# **Pentium® II Processor Specification Update**

Release Date: October 1997

Order Number: 243337-006

Figure 7. S.E.C. Cartridge Bottom Side View

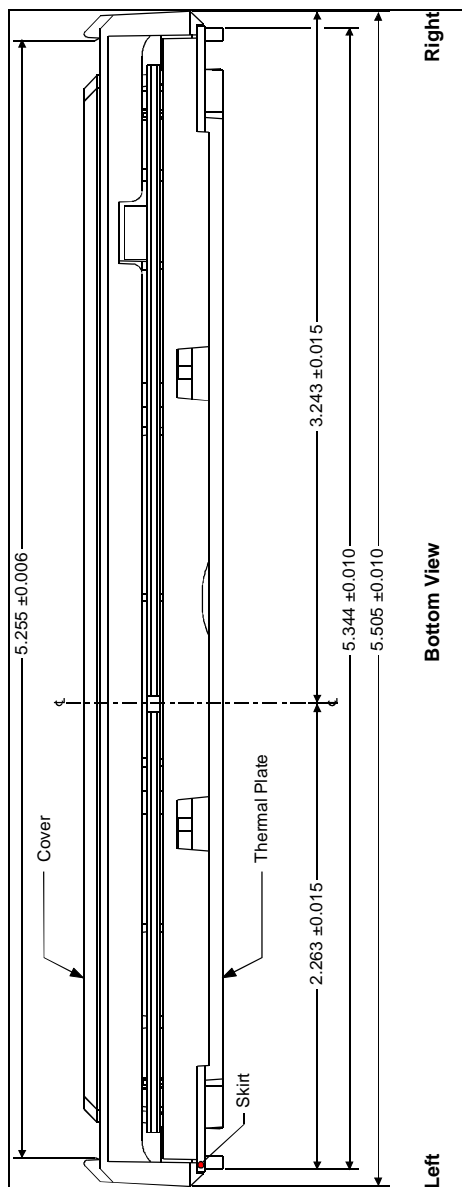
**\*\* Added Figure 9, Figure 7 corrected a dimension, Figure 8 clarified dimensions, Figure 10 corrected dimensions**

**Figure 12. Heatsink Attachment Mechanism Design Space**

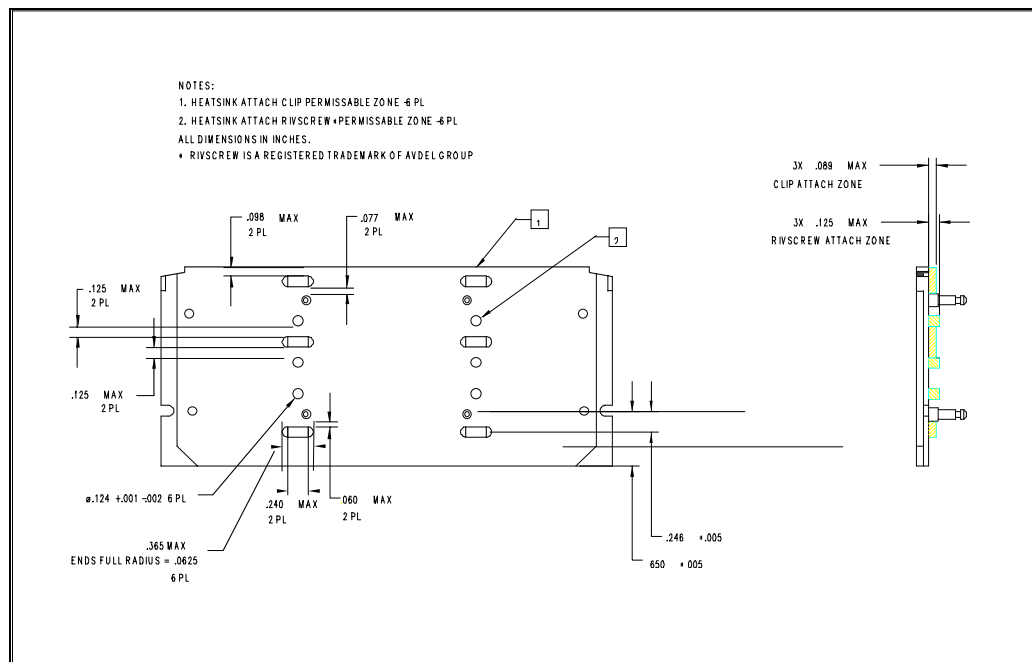
A change to the attach mechanism specification is provided below. The original specification for clearance of heatsink attach solutions is provided in Section 4.3 (and Figure 23 and Figure 24) in the *Pentium® II Processor at 233 MHz, 266 MHz and 300 MHz* datasheet. Figure 11 shows the revised maximum specifications for heatsink clip and RivscREW® attach mechanism designs. All heatsink clip and RivscREW attachment solutions must remain within the respective maximum “permissible” zone as detailed in Figure 11.

The thermal plate shown in Figure 11 is used to portray the heatsink attach mechanism design space for the future Slot 1 processors. However, the maximum “permissible” design space is also valid for both the current Pentium II and future Slot 1 processors.

Please review the proposed specifications to guarantee compatibility with existing Pentium II and future Slot 1 processor heatsink attachment solutions. Note that the required heatsink attachment solution space should not exceed the maximum proposed design space while installed or during the installation and removal procedure.
